ECE/TRANS/WP.29/GRSP/2009/19
23 September 2009

REGULATION No. 29
(Cabs of commercial vehicles)

Proposal for the 03 series of amendments to Regulation No. 29

Submitted by the secretary of the Cab Strength Informal Group */

Fig. 1 – Front impact test (test A).

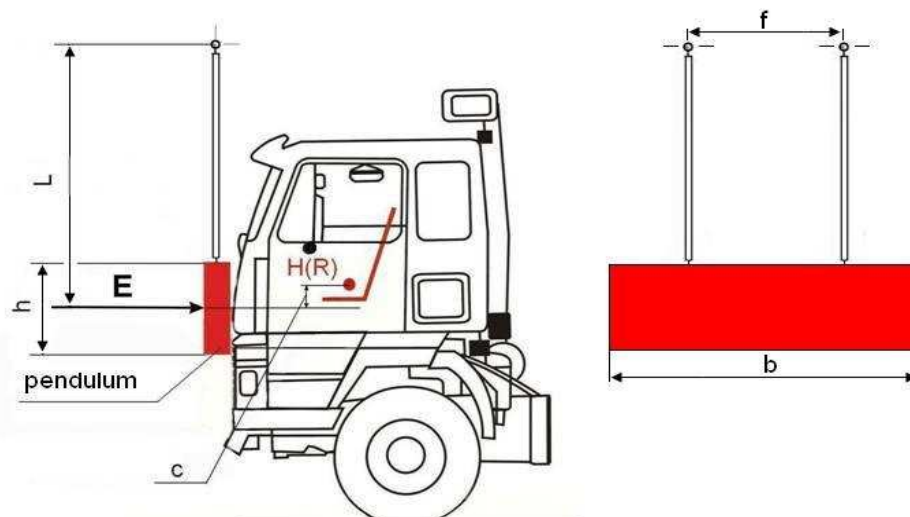
New Figure explaining the frontal impact test - Test A.

- 5.1.** The ~~impactor swing-bob~~ shall be made of steel and its mass shall be evenly-distributed; its mass shall **not be less than 1,500 ± 250 kg**. Its striking surface, rectangular and flat, shall be 2,500 mm wide and 800 mm high (**see b and h on Figure 1**). Its edges shall be rounded to a radius of curvature of not less than [1.5] mm.

- 5.2.** The ~~impactor swing-bob~~ assembly shall be of rigid construction. The ~~impactor swing-bob~~ shall be freely suspended by two beams rigidly attached to it and spaced not less than 1,000 mm apart (**see f on Figure 1**). ~~The beams shall be of "I" section with a web height of not less than 100 mm or shall be of a section having at least an equivalent moment of inertia.~~ The beams shall be not less than 3,500 mm long from the axis of suspension to the geometric centre of the ~~bob~~ **impactor (L on Figure 1)**.

- 5.3.** The ~~swing-bob~~ **impactor** shall be so positioned that in the vertical position:
- 5.3.1.** its striking face is in contact with the foremost part of the vehicle;

- 5.3.2.** its centre of gravity is $c=50 +5/ - 0$ mm below the R point of the driver's seat, and
- 5.3.3.** its centre of gravity is in the median longitudinal plane of the vehicle.

Fig. 2. – Front pillar impact test (Test B).

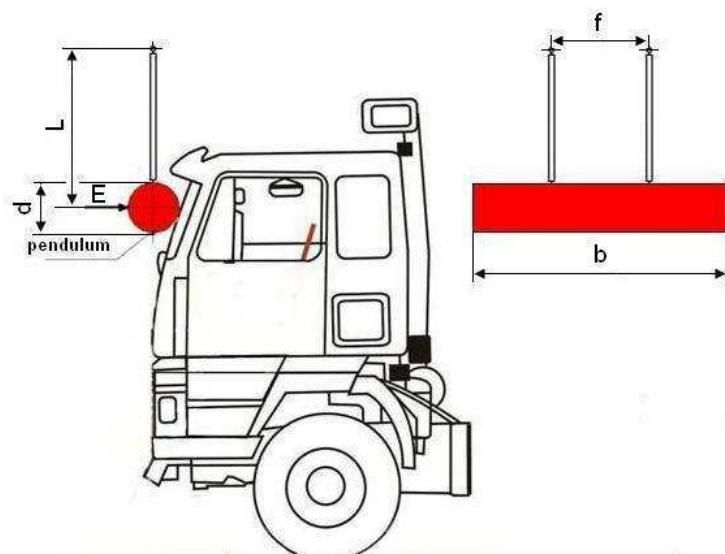
New Test B, including figure 2.

Suggestion to delete specification on material (steel): it is sufficient to specify that the impactor must be rigid.

Taking into account the commercial availability of such impactors, it is suggested to add a tolerance of ± 50 mm.

- 6.1. The impactor shall be rigid [~~be made of steel~~] and its mass shall be evenly-distributed; its mass shall not be less than 1,000 kg. The impactor shall be cylindrical with a diameter d of the cylinder of 600 $[\pm 50]$ mm and a length b of not less than 2,500 mm. Its edges shall be rounded to a radius of curvature of not less than [15] [1.5] mm.

- 6.2. The impactor assembly shall be of rigid construction. The impactor shall be freely suspended by two beams rigidly attached to it and spaced not less than $f = 1,000$ mm apart. The beams shall be of "I" section with a web height of not less than 100 mm or shall be of a section having at least an equivalent moment of inertia. The beams shall not be less than $L = 3,500$ mm long from the axis of suspension to the geometric centre of the ~~bob~~ impactor.

Fig. 3. Roof strength test (Test C).

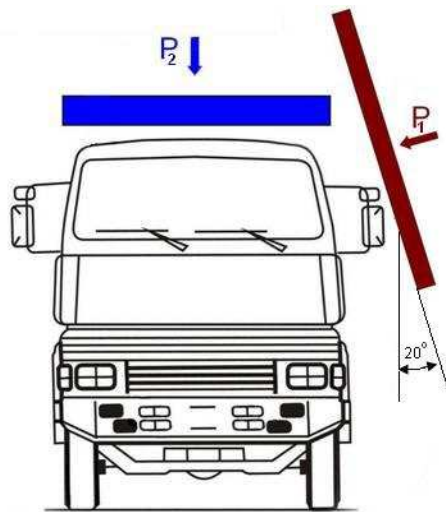
New Test C, including figure 3.

- 7.1 For vehicles of category N_2 with a gross vehicle mass exceeding 7.5 t and of category N_3 , both tests as described in paragraphs 7.3 and 7.4 below, in that order, shall be conducted on the same cab
- 7.2 For vehicles of category N_2 with a gross vehicle mass not exceeding 7.5 t and of category N_1 , only the test as described in paragraph 7.4 below shall be conducted
- 7.3 Dynamic pre-loading of vehicles of category N_2 with a gross vehicle mass exceeding 7.5 t and of category N_3 (see P_1 on Figure 3).
- 7.3.1 The impactor shall be rigid and its mass shall be evenly distributed; its mass shall not be less than 1,500 kg.
- 7.3.2 The striking surface of the impactor shall be rectangular and flat. Its dimensions shall be sufficiently large such that, when positioned in accordance with paragraph 7.3.3 below, no contact will occur between the cab and the edges of the impactor.

- 7.3.3. The impactor and/or the cab shall be so positioned that, at the time of impact:**
- 7.3.3.1. the striking face of the impactor is at an angle of 20° to the median longitudinal plane of the cab. Either the impactor or the cab may be tilted;**

- 7.3.5. The impact energy shall be minimum 17.6 kJ.**
- 7.4. Roof strength test (see P₂ on Figure 3)**
- 7.4.1. The loading device shall be made of steel and its mass shall be evenly distributed.**

Fig. 4. – Rear-wall strength test

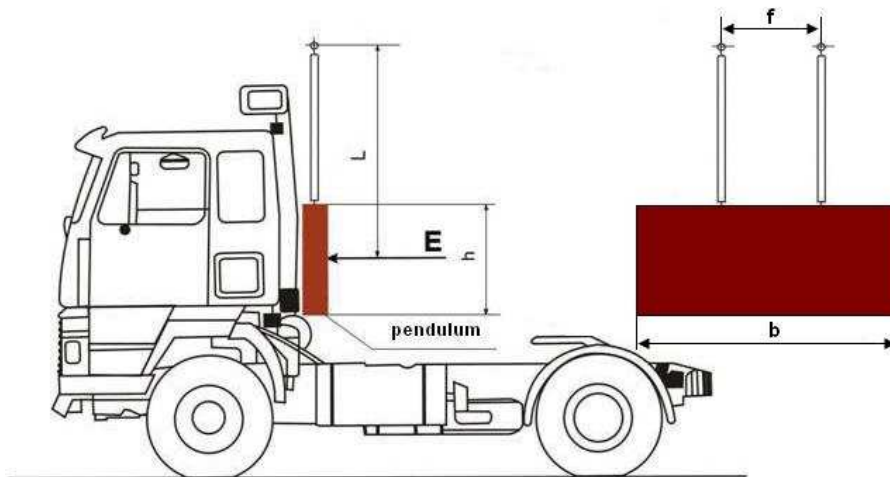
Issue of test D must still be finalised, therefore square brackets were added.

8.2. Vehicles of category N₂ with a gross vehicle mass exceeding 7.5 t and of category N₃ (see Figure 4)

8.2.1. The impactor shall be made of steel and its mass shall be evenly distributed; its mass shall not be less than 1,500 kg. Its striking surface, rectangular and flat, shall be b = 2,500 mm wide and h = 800 mm high. Its edges shall be rounded to a radius of curvature of not less than [15] mm.
